From: Jim Lieb [jlieb@giant.com]
Sent: Thursday, June 22, 2006 3:00 PM
To: Chavez, Carl J, EMNRD
Cc: Monzeglio, Hope, NMENV; Cobrain, Dave, NMENV; Price, Wayne, EMNRD; Foust, Denny, EMNRD; Powell, Brandon, EMNRD; Ed Riege; Ed Rios
Subject: RE: Ciniza Flow Meters
Importance: High
Attachments: FlumeSelectionSheet.xls; NAPISDiagram.pdf

Flow Meter Installation (TENTATIVE under evaluation)

Giant Refining - Ciniza Refinery

API CHOPPER PUMP
PIPING PLAN AND ELEVATIONS

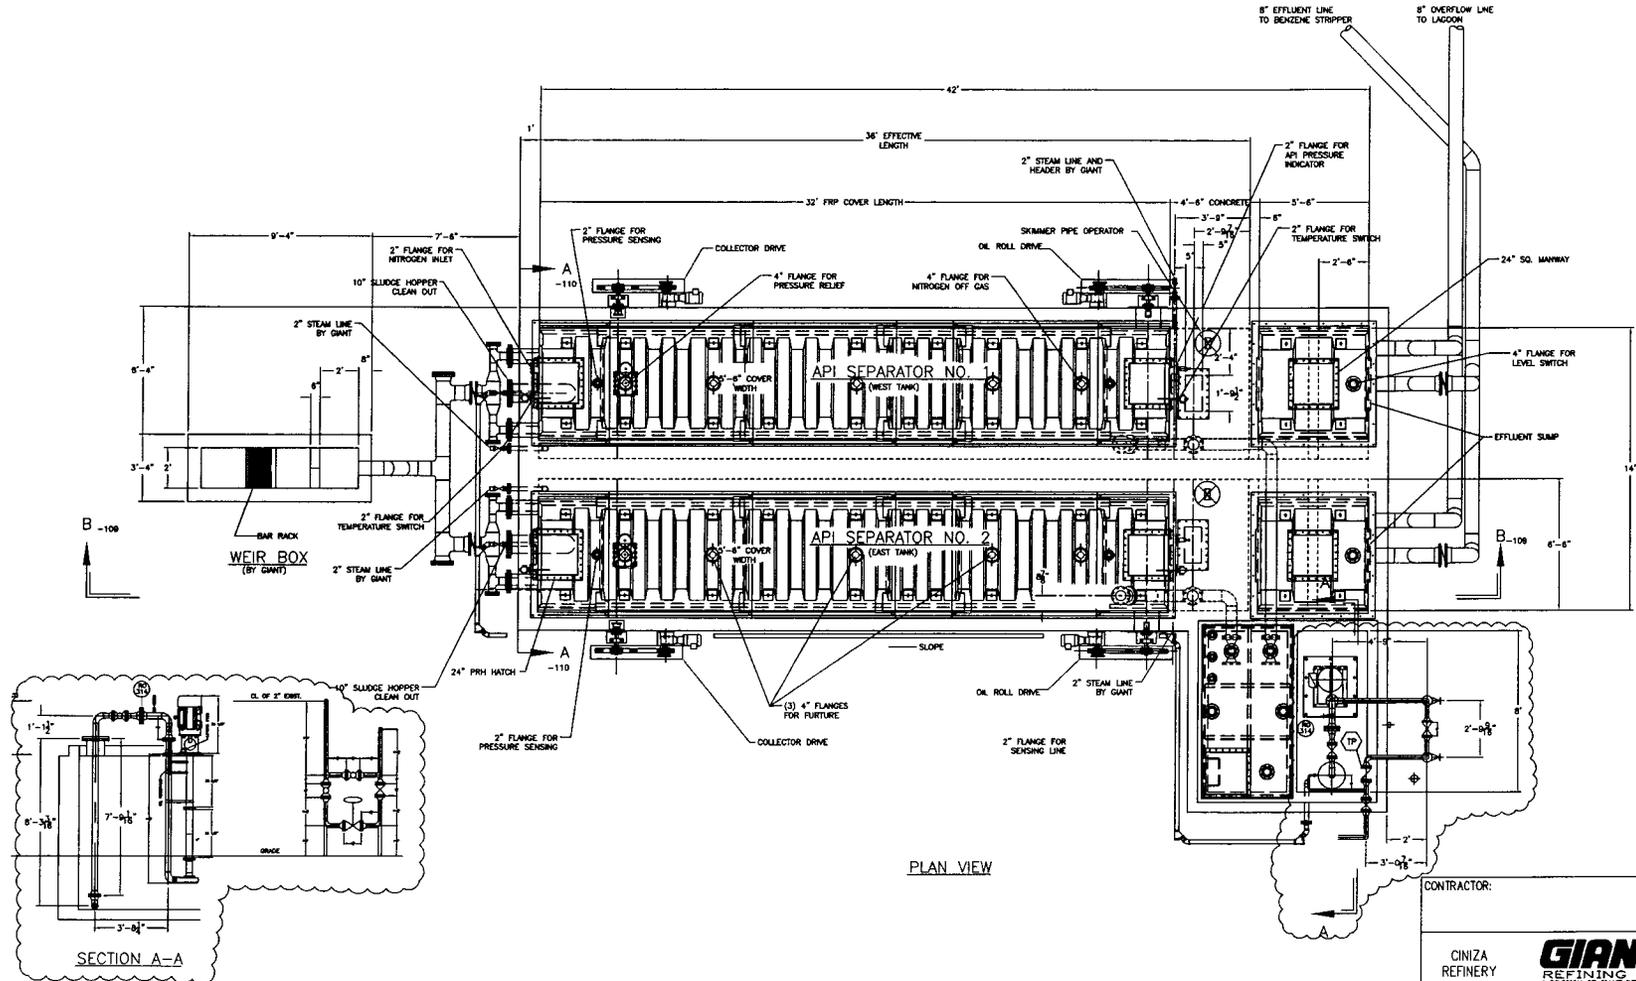
Regarding the New API Separator, we are awaiting an as-built drawing to scale to help evaluate the problem there. We did receive a couple of drawings, but they do not appear to reflect the as-built or current construction and/or site-specific conditions at and near the NAPI at Ciniza.

Regarding the New API Separator, we are awaiting an as-built drawing to scale to help evaluate the problem there. We did receive a couple of drawings, but they do not appear to reflect the as-built or current construction and/or site-specific conditions at and near the NAPI at Ciniza.

After receiving a couple of drawings of the NAPI, we are wondering whether the drawings reflect the more recent construction activities, i.e.; installation and/or repair of the secondary containment system, as built specifications, etc? Please clarify that the drawing represent the current construction of the NAPI or send current as-built drawings (to scale) for our review.

I have attached a scan of the latest diagram of our NAPIS; it shows the chopper pump installation. As an alternative to digging under the NAPIS and repairing the liner (which will be very difficult and potentially dangerous) we are considering the injection of bentonite sealing grout into the leaking zone surrounding the NAPIS. Then, in the event this does not eliminate the leakage, we will consider installing a liner **inside** the NAPIS. I am currently awaiting a proposal for the bentonite grout injection work.
